Amphenol Canada Corp - Product Change Notice (PCN)

| Amphenol Canada PCN Number | PCN-C1465 |
| Description of Change #1 | Change the hex nut thickness from 3.0mm to 5.0mm as below picture show.  |

DWG. NO. **P-MRD-AH02-L13-000** REV **C**

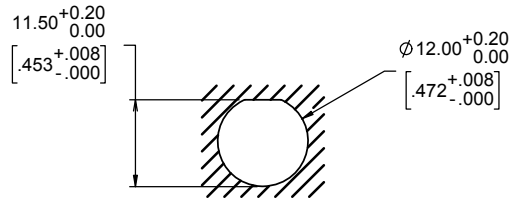
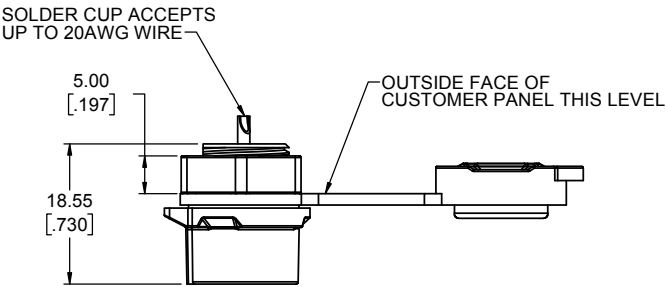
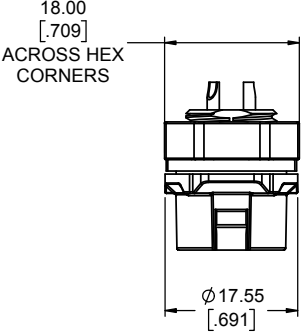
| REVISIONS | | | |
|-----------|---------------------------------|----------|-------|
| C | MODIFY THE NUT THICKNESS TO 5mm | FEB27/20 | A.G. |

| DWG. NO. | P-MRD-AH04-L13-000 |

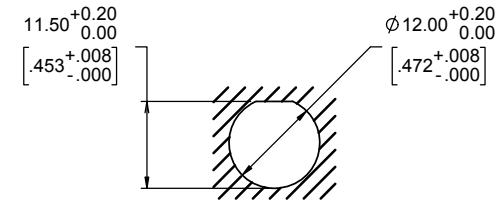
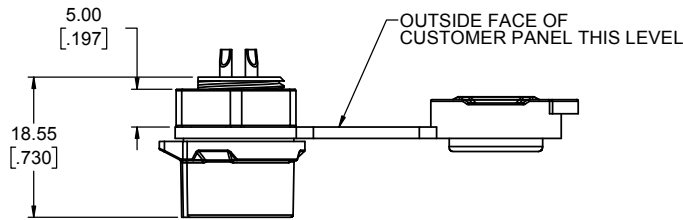
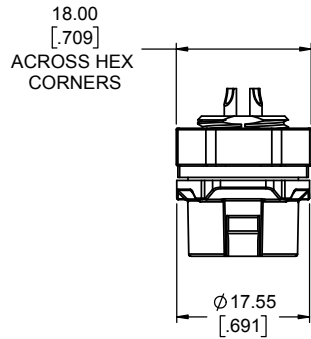
NUMBER OF CONTACT
04=FOUR CONTACTS

DWG. NO. **P-MRD-AH05-L13-000** REV **B**

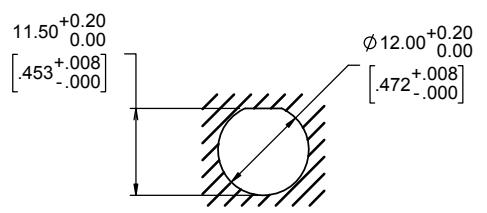
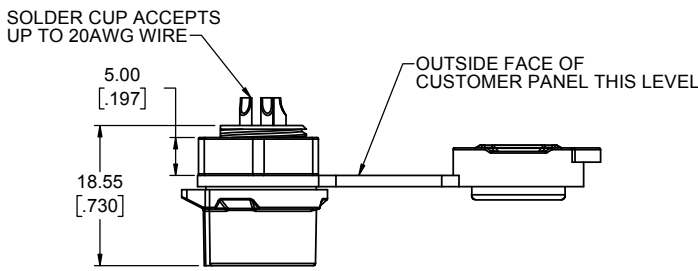
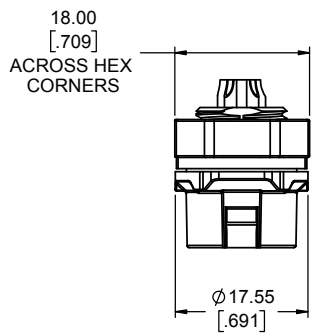
| REVISIONS | | | |
|-----------|---------------------------------|----------|-------|
| B | MODIFY THE NUT THICKNESS TO 5mm | FEB27/20 | A.G. |

| DWG. NO. | P-MRD-AH06-L13-000 | | REV C |

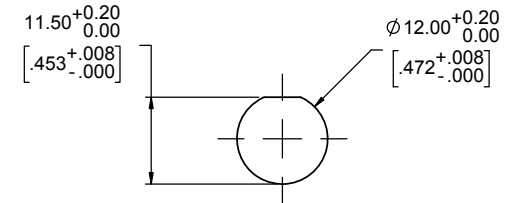
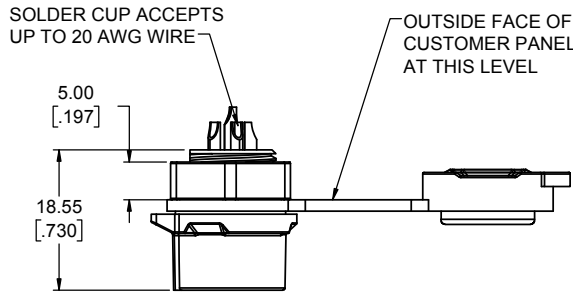
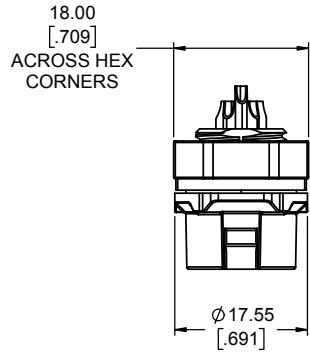
| REVISIONS | | | |
|-----------|---------------------------------|----------|-------|
| C | MODIFY THE NUT THICKNESS TO 5mm | FEB27/20 | A.G |

DWG. NO. **P-MRD-AH07-L13-000** REV **B**

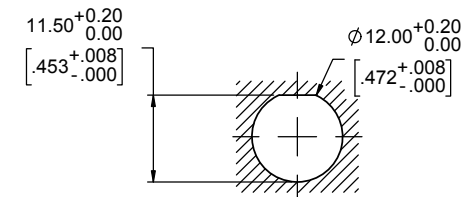
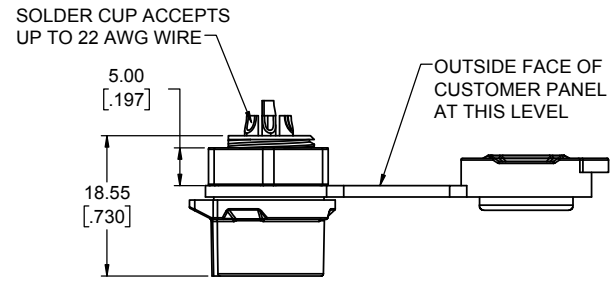
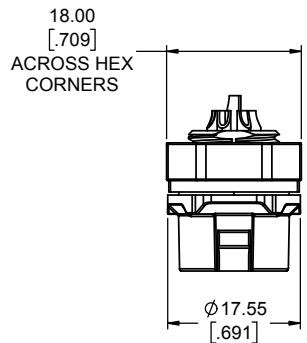
| REVISIONS | | | |
|-----------|---------------------------------|----------|-------|
| B | MODIFY THE NUT THICKNESS TO 5mm | FEB27/20 | A.G. |

| DWG. NO. | P-MRD-AH08-L13-000 | | REV B |

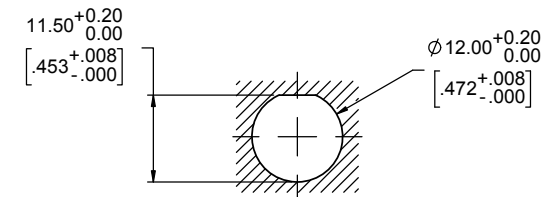
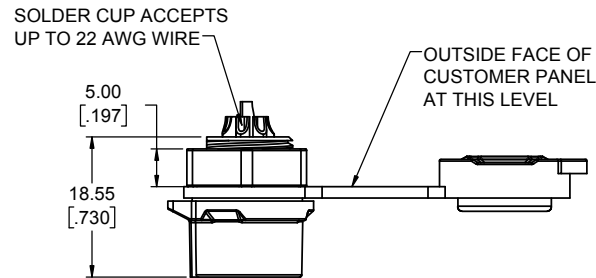
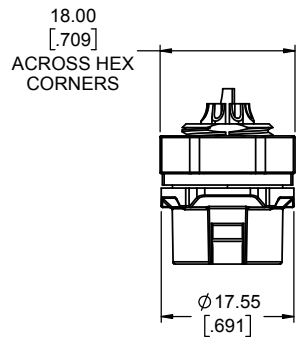
| REVISIONS | | | |
|-----------|---------------------------------|----------|-------|
| B | MODIFY THE NUT THICKNESS TO 5mm | FEB27/20 | A.G. |

DWG. NO. **P-MRD-AX03-L13-000** REV **F**

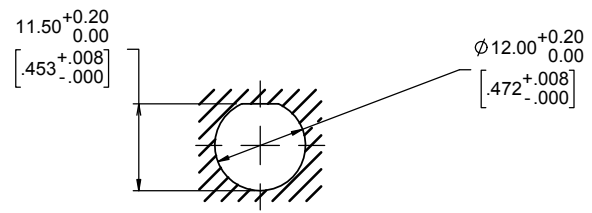
| REVISIONS | | | |
|-----------|---------------------------------|----------|-------|
| F | MODIFY THE NUT THICKNESS TO 5mm | MAR02/20 | A.G. |

DWG. NO. **P-MRD-AX03-L13-000** REV **F**

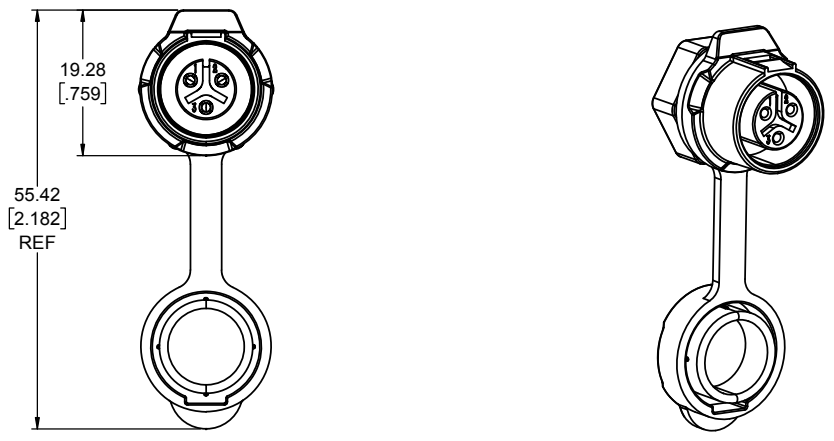
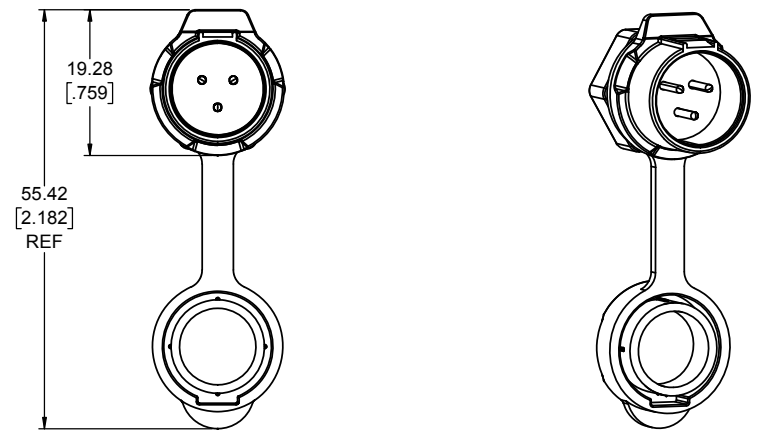
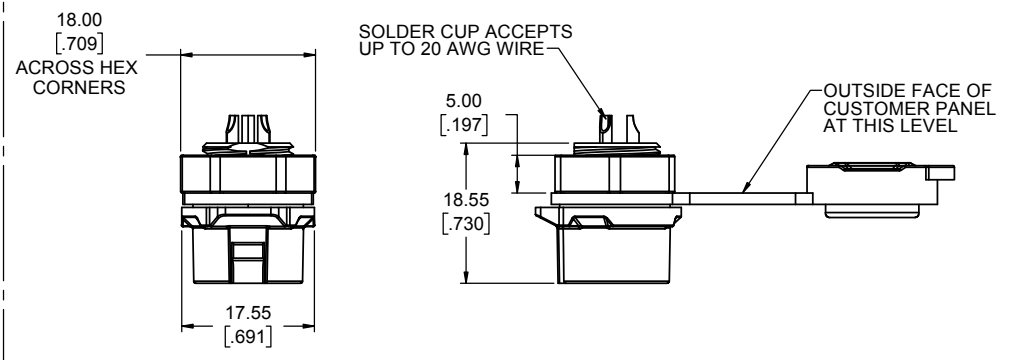
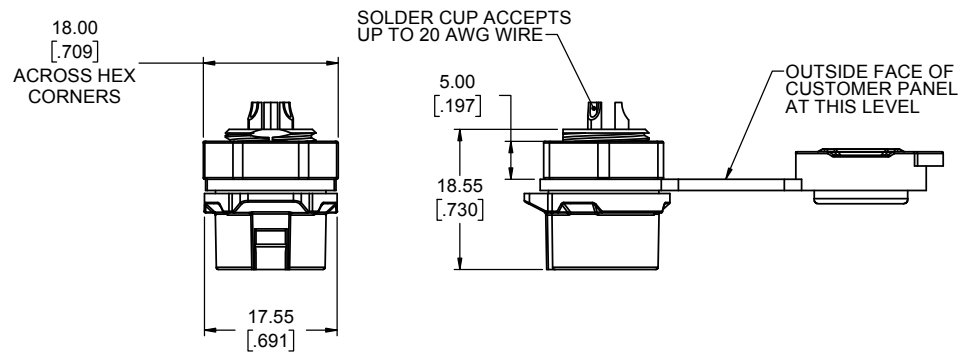
| REVISIONS | | | |
|-----------|---------------------------------|----------|-------|
| F | MODIFY THE NUT THICKNESS TO 5mm | MAR02/20 | A.G. |
